# SUNSET VILLAGE FILING NO. 4

## CONSTRUCTION PLANS

EPC STORMWATER REVIEW COMMENTS  
IN ORANGE BOXES WITH BLACK TEXT

MODIFIED FOR S.I.A. CD SET  
RICHARD D. LYON, PE  
ATWELL, LLC.  
DECEMBER, 2021  
EPC PROJ.: CDR-21-008

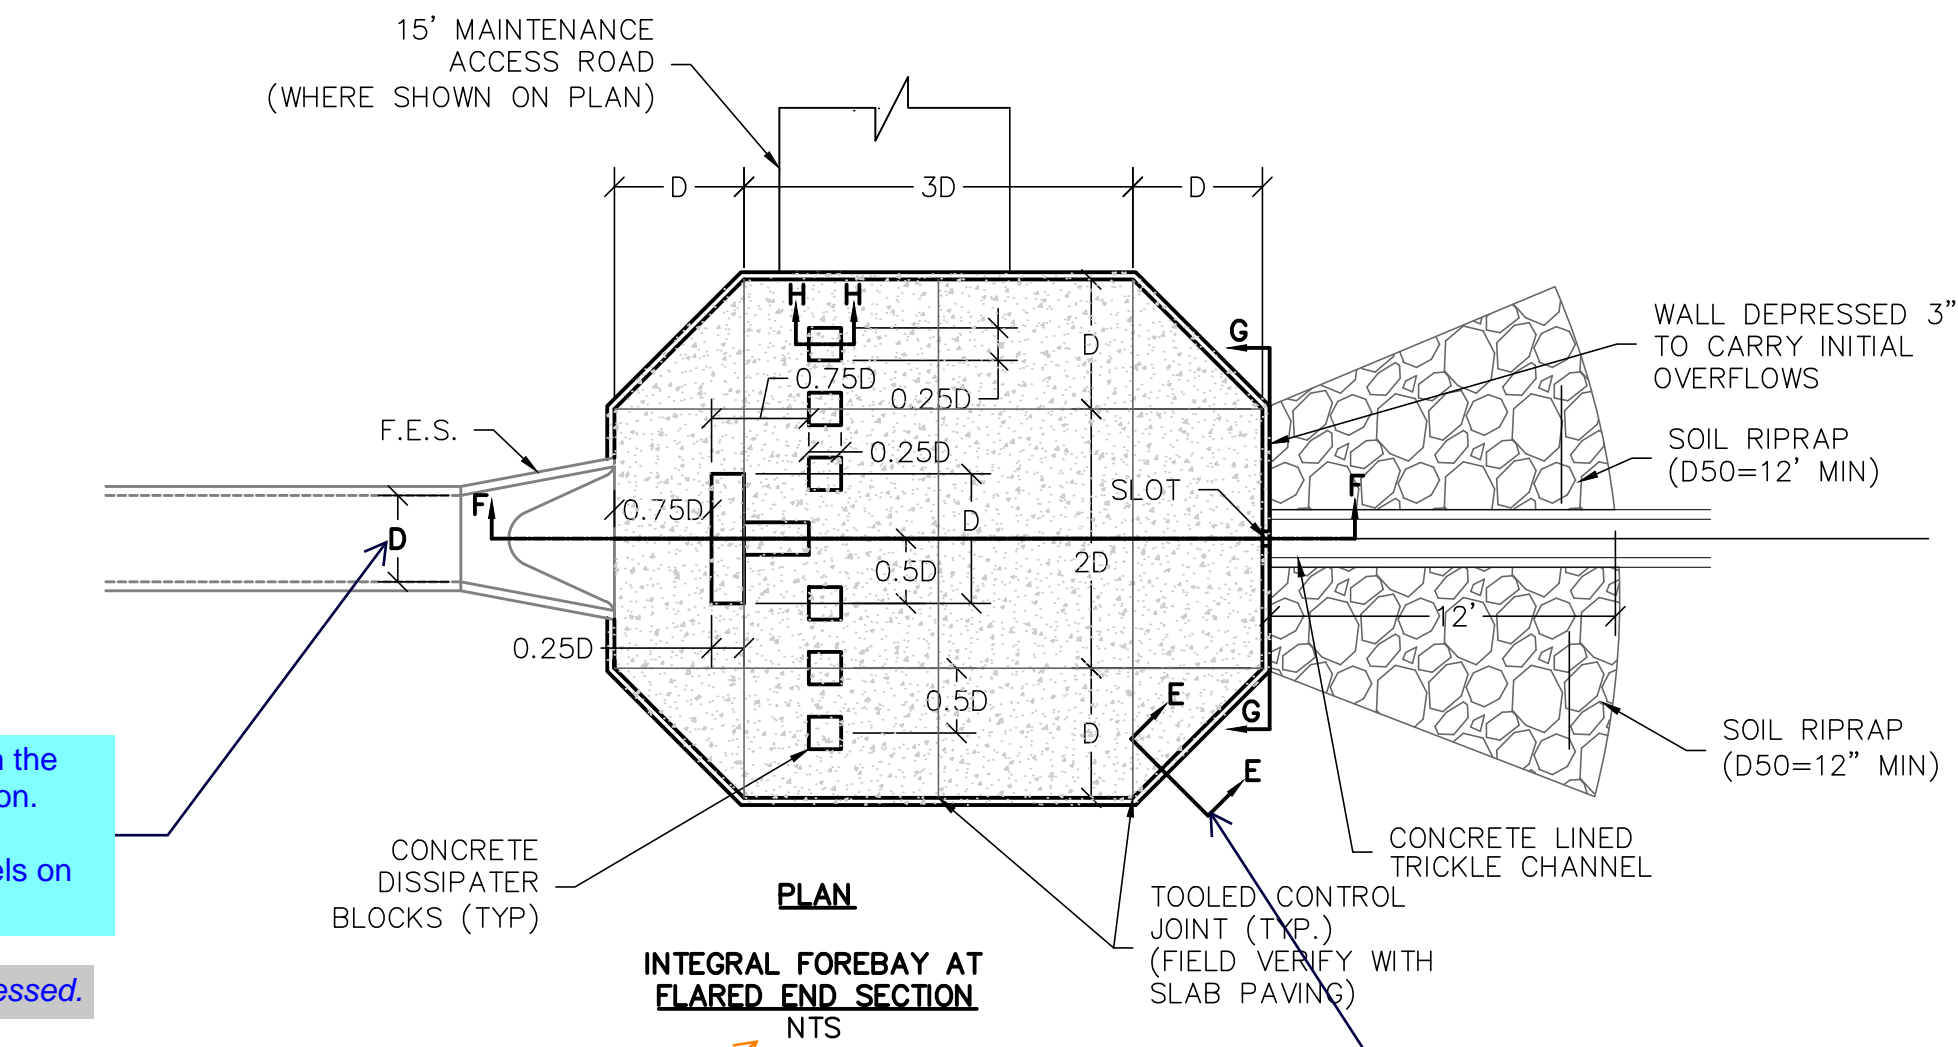
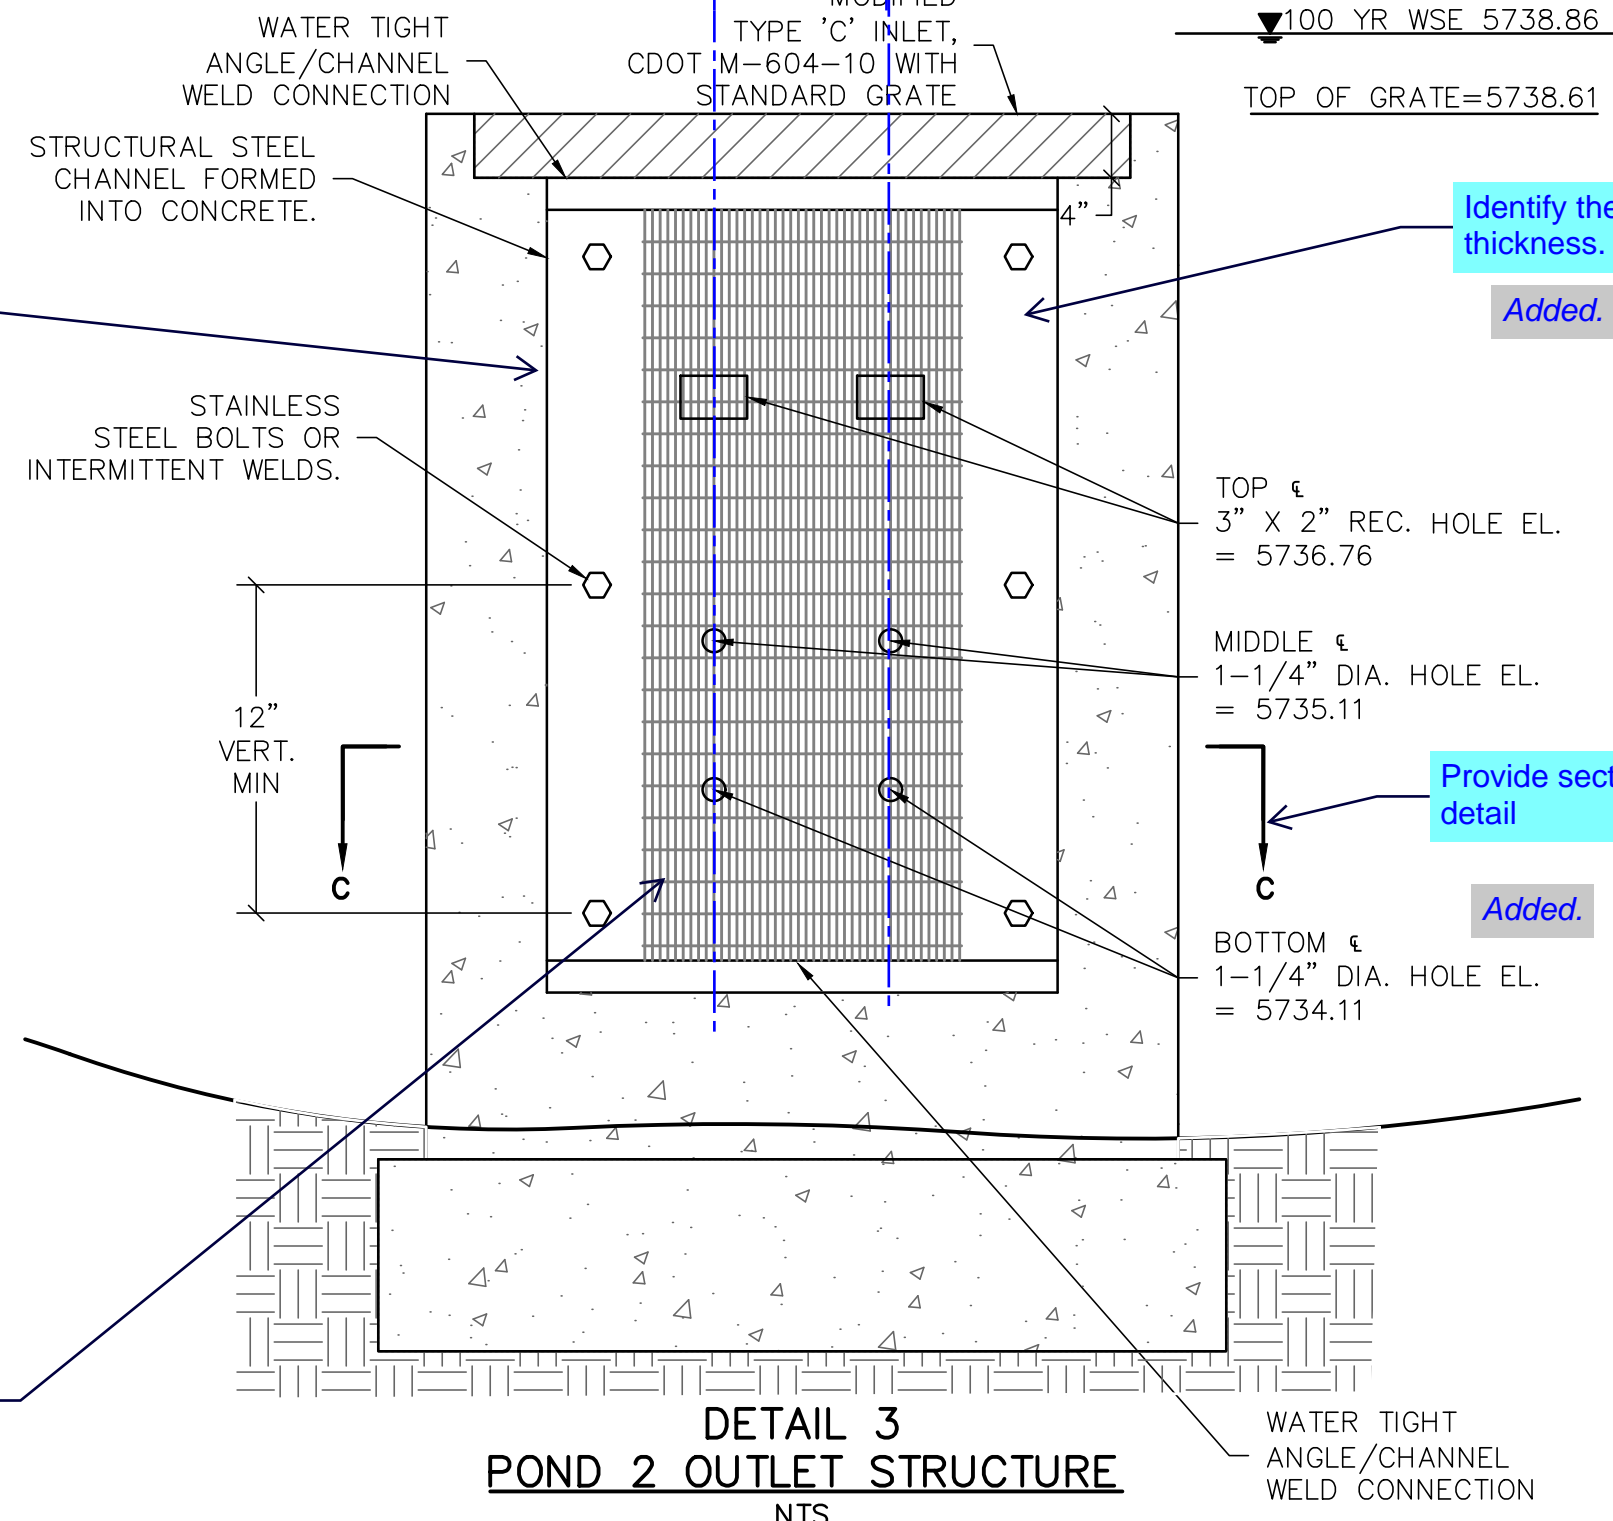
add dimension label for the separation between each column  
Added.

Identify the plate thickness.  
Added.

Provide section C-C detail  
Added.
